Table-Top Engineering Evaluation

Tank 48 Alternate Technology Table Top Engineering Evaluation

5/25/2011 Savannah River Site, 766-H, Rm. 1026

Tank 48 Treatment Project Table-Top Engineering Evaluation Review and Charter

Figure 1: Direct Vitrification of Tank 48 Waste

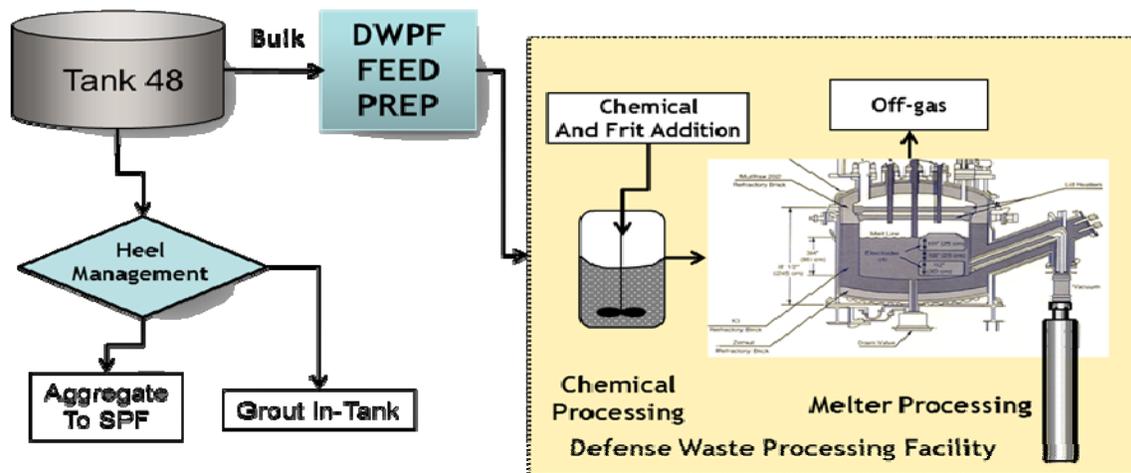
A summary of direct vitrification is shown in Figure 1. The bulk of the material will be sent to the Defense Waste Processing Facility (DWPF) for vitrification. The remaining heel will be disposed through aggregation at the Saltstone Production Facility (SPF) or grouted in-tank in compliance with closure documentation. The technology maturation for the direct vitrification will be performed in light of the intended DWPF process enhancements.

Figure 2: Technology Maturation for Direct Vitrification of Tank 48 Materials

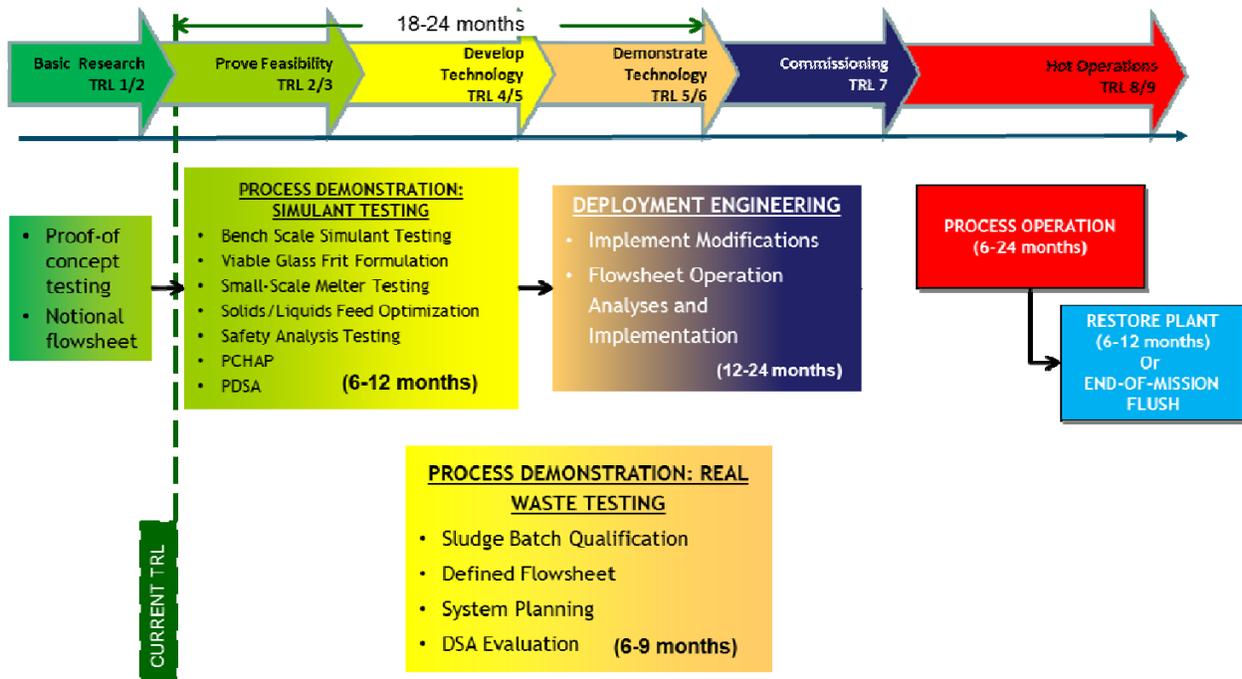
A summary of the needed technology maturation for direct vitrification of Tank 48 materials is shown in Figure 2. The technology maturation will have to include a detailed analysis of the off-gas impacts from vitrification of the Tank 48 materials. The current TRL is estimated at 2, however, it is recognized that the DWPF has significant experience in sludge batch qualification and execution.

Figure 3: Conceptual Small-Tank Copper Catalyzed Peroxide Oxidation

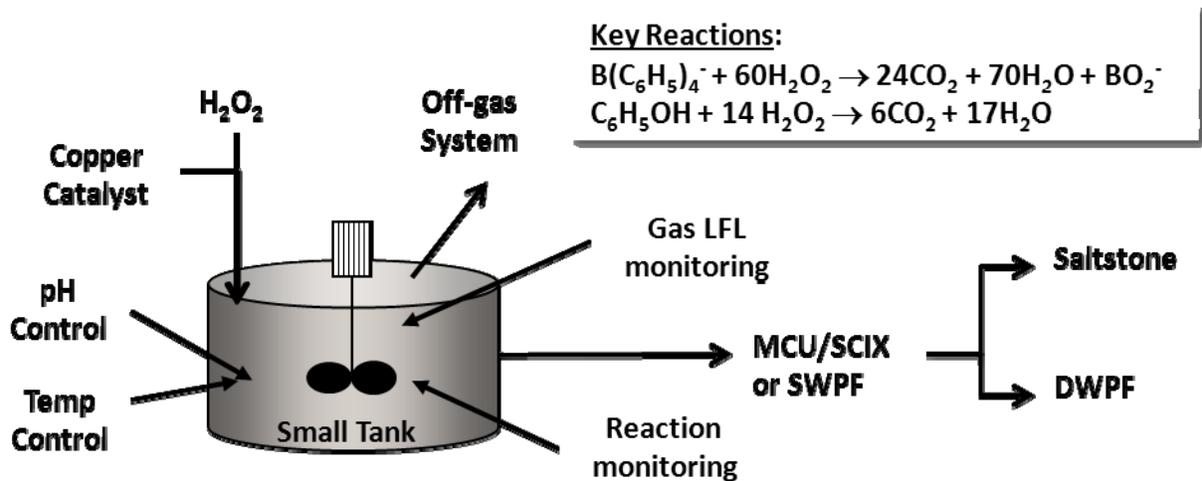
A summary of chemical destruction is shown in Figure 3. The proposed chemical destruction flowsheet for decomposition of the organics in Tank 48 is a copper catalyzed peroxide oxidation reaction, with the TPB oxidized to carbon dioxide. The proposed treatment chemistry is the combination of hydrolysis with Fenton's chemistry which involves the addition of hydrogen peroxide (oxidizer) and a metal catalyst, usually iron or copper in this case, to create hydroxyl free radicals ($\cdot\text{OH}$) and hydroxide ions (OH^-). The free radicals are consequently responsible for the destruction of the organics. While the Fenton's chemistry typically proceeds at a pH of 3-5, the copper enhancement allows the reaction to proceed with reasonable kinetics at higher pH, conducive to corrosion control on the carbon steel wall of the tank. The copper may also play a role in catalyzing the solution phase hydrolysis reaction. In addition, review of the chemical destruction technology will consider the feasibility of an uncatalyzed hydrolysis reaction, if there is a surface (solid-liquid) interaction.

Figure 4: Technology Maturation for Chemical Destruction of Tank 48 Organics

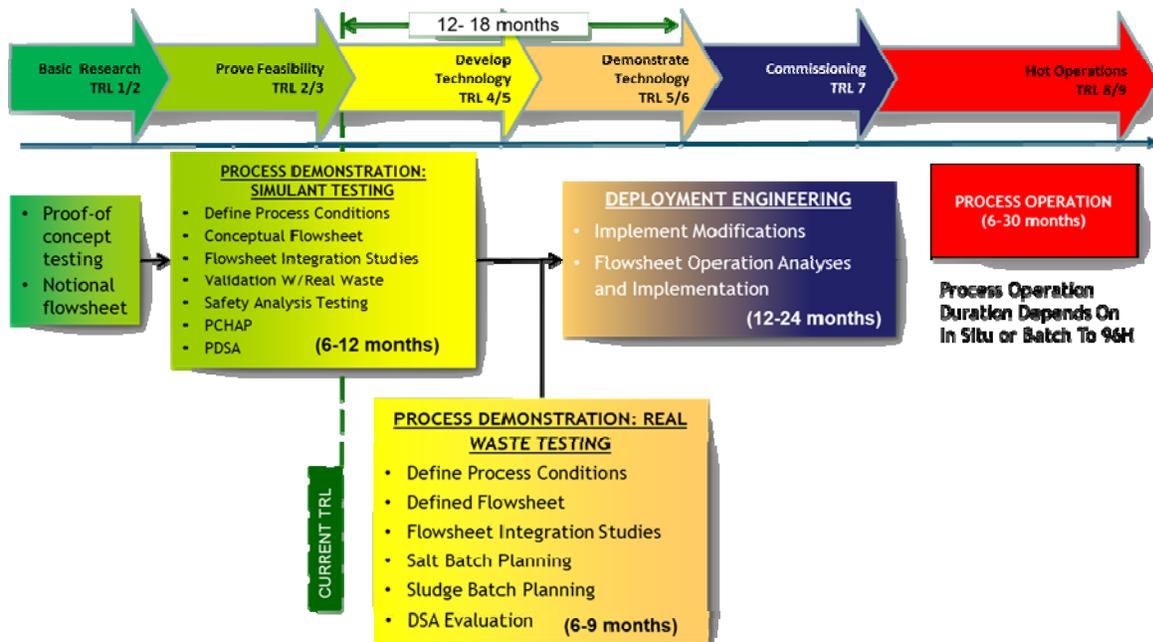
A summary of the needed technology maturation for chemical destruction is shown in Figure 2. The current TRL is estimated at 3, since simulant testing has been performed.
